Watts Bar Nuclear Plant, Unit 2  
NRC Docket No. 50-391

**Subject: WATTS BAR NUCLEAR PLANT (WBN) UNIT 2 – REQUEST FOR  
ADDITIONAL INFORMATION REGARDING CONSTRUCTION  
REFURBISHMENT PROGRAM PLAN (TAC NO. MD6581)**

### Request for Additional Information – Construction Refurbishment Program Plan

45W860-11

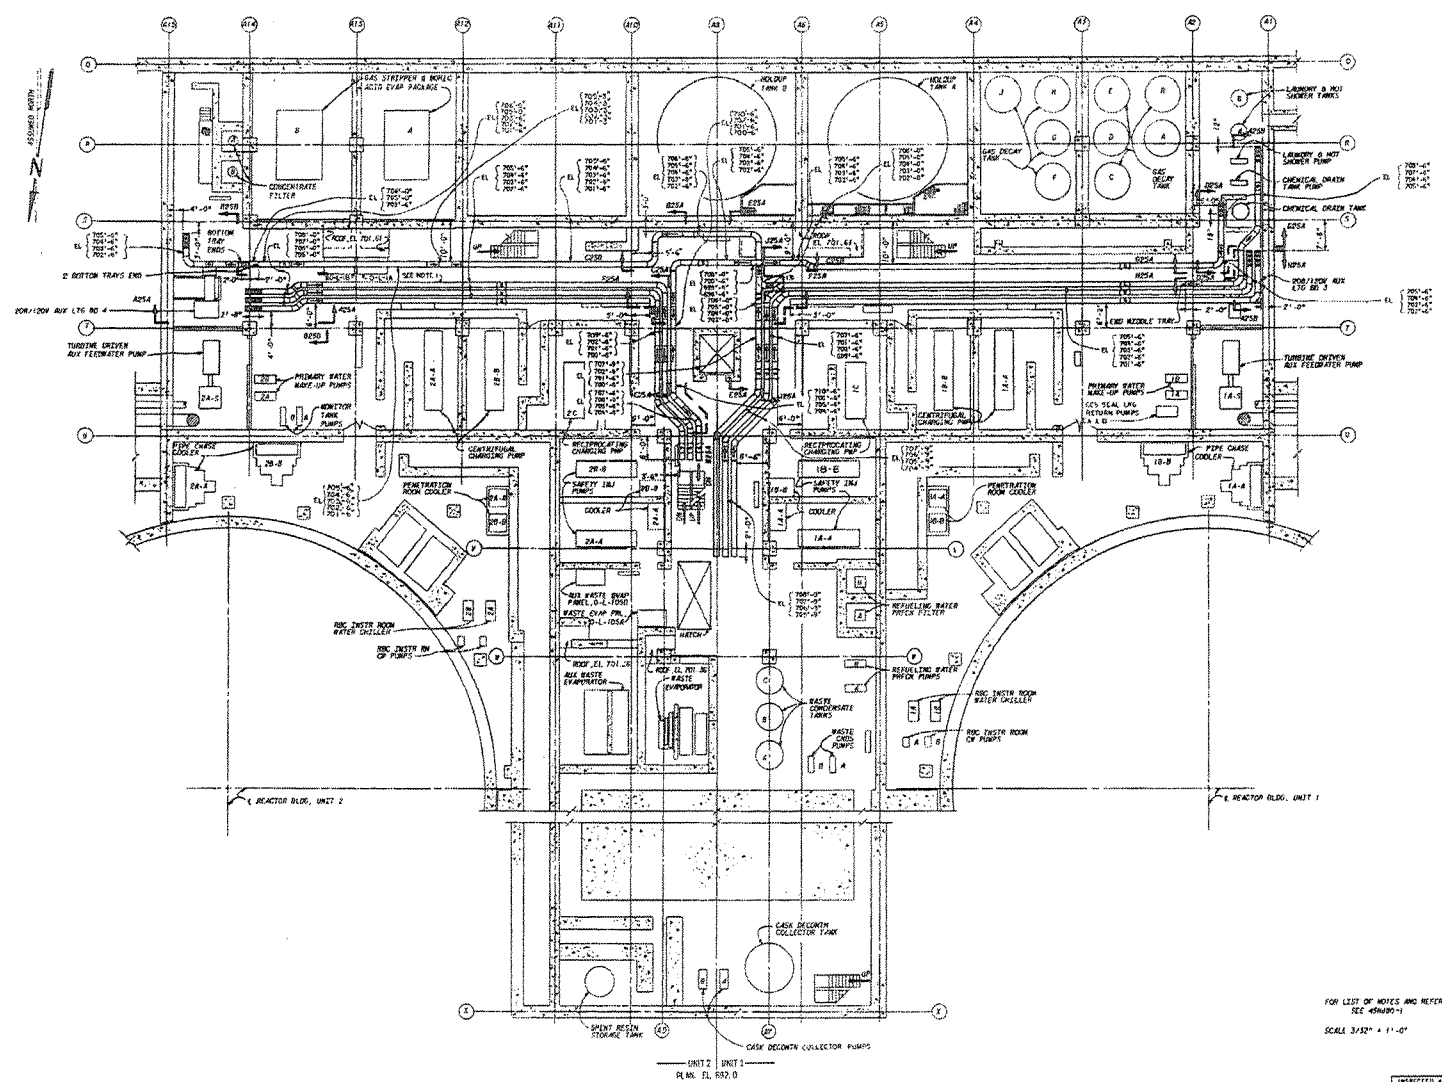
- g. Describe *how WBN Unit 2 cables located near Unit 1 equipment have been evaluated to determine if vibration may have adversely impacted these cables.*

WBN Units 1 and 2 have defined spaces in the auxiliary building where vibrating equipment, such as pumps and fans, is located. Unit 1 is located west of column line A8 and Unit 2 on the east side of column line A8 (refer to the drawing in the Attachment to this Enclosure). The cables from the cable trays fan out in the opposite directions in order to serve their respective unit. Therefore, there are no Unit 2-specific cables near Unit 1 vibrating equipment. The same is true for Unit 1. The in-service Unit 2 equipment is under Unit 1 control and is assessed in accordance with the maintenance rule and/or 10 CFR 50.49.
